Final Major Site Plan & Final Major Subdivision Applications

Marigold Lane Subdivision

250 Windham Center Road
Windham, Maine

Response to Town Review Comments
Marigold Lane Subdivision – formerly 250 Windham Center Road Subdivision
Casco Bay Holdings, LLC - Applicant

PROPOSED BUILDING ARCHITECTURAL PLANS

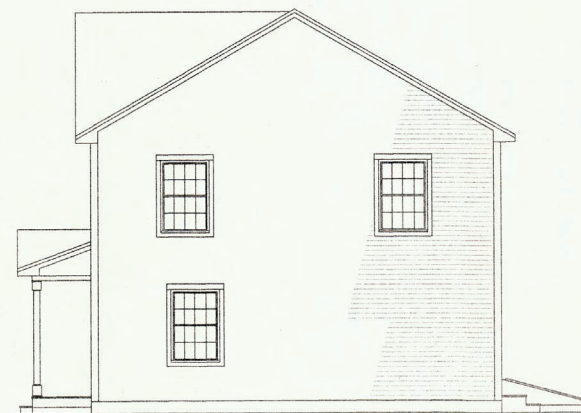
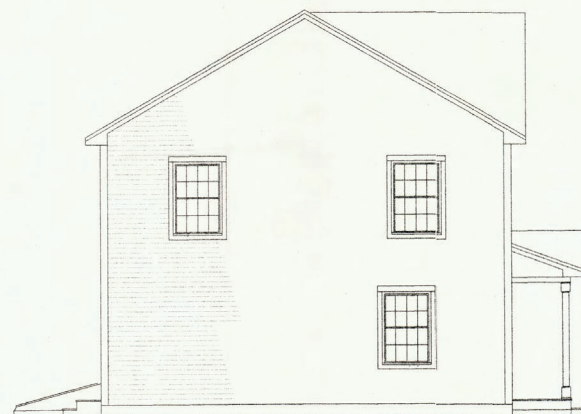
- a) *At least two different building designs shall be provided as required by §120-814A(1).*

Response #6a – We are proposing to construct the middle building (Units 3 & 4) with a hip roof to create two building forms for the project. The other two buildings (Units 1, 2, 5 & 6) will have the gable-end roof as shown on the plans contained in Section 7 of the application. See additional explanation in Section 9 of the application related to Multi-family development standards.

NOTE: UNITS 1,2,5 & 6 ROOF WILL BE GABLE-END STYLE
UNITS 3,4 (MIDDLE BUILDING) WILL HAVE HIP ROOF STYLE
